TO: Town of Parker Recreation Department, Brett Collins
FROM: Carolyn Parkinson, Planner I
DATE: November 15, 2022
SUBJECT: SP22-099; Ray J. Harvie L1 Open Space
Review Comments 02

Staff Comments 02
SP22-099; Ray J. Harvie LI Open Space
November 15, 2022

4 COBBLE PAVING NOT TO SCALE

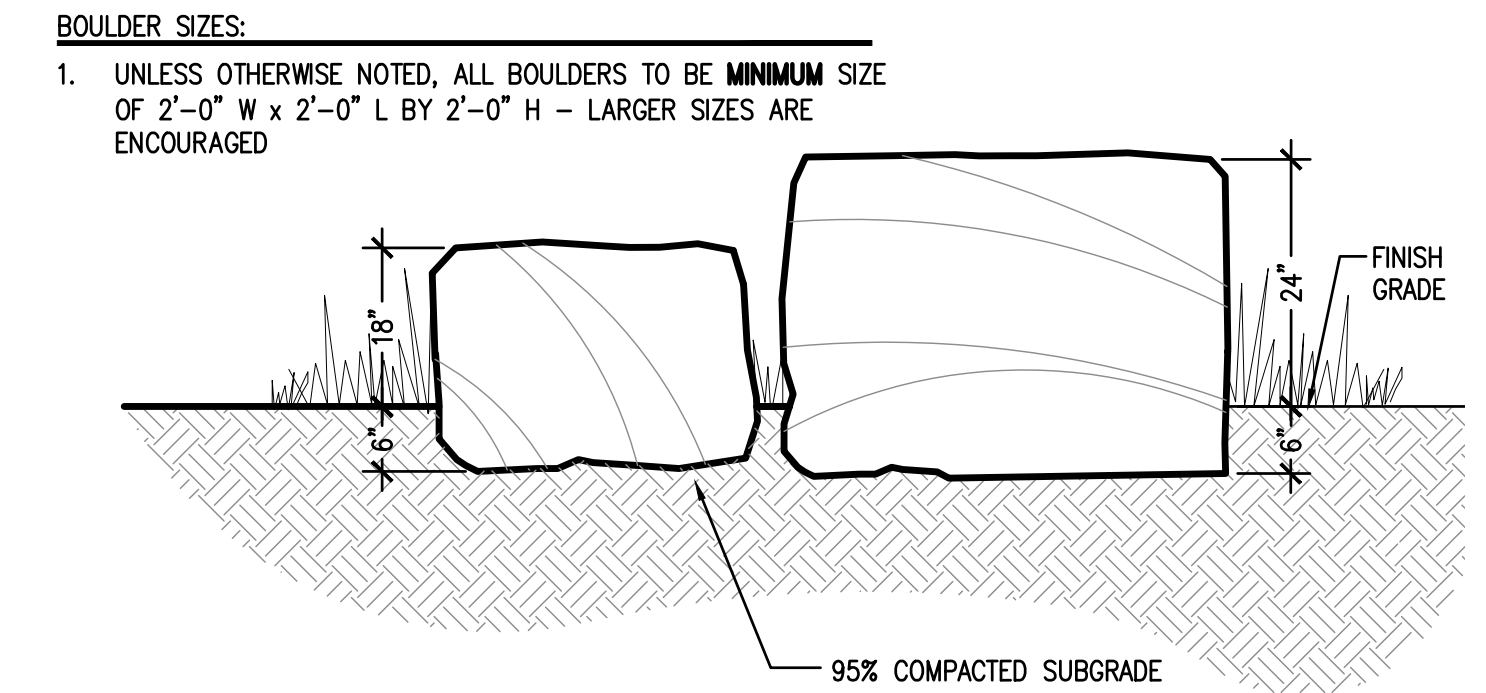
Staff cannot locate "Cobble Paving".
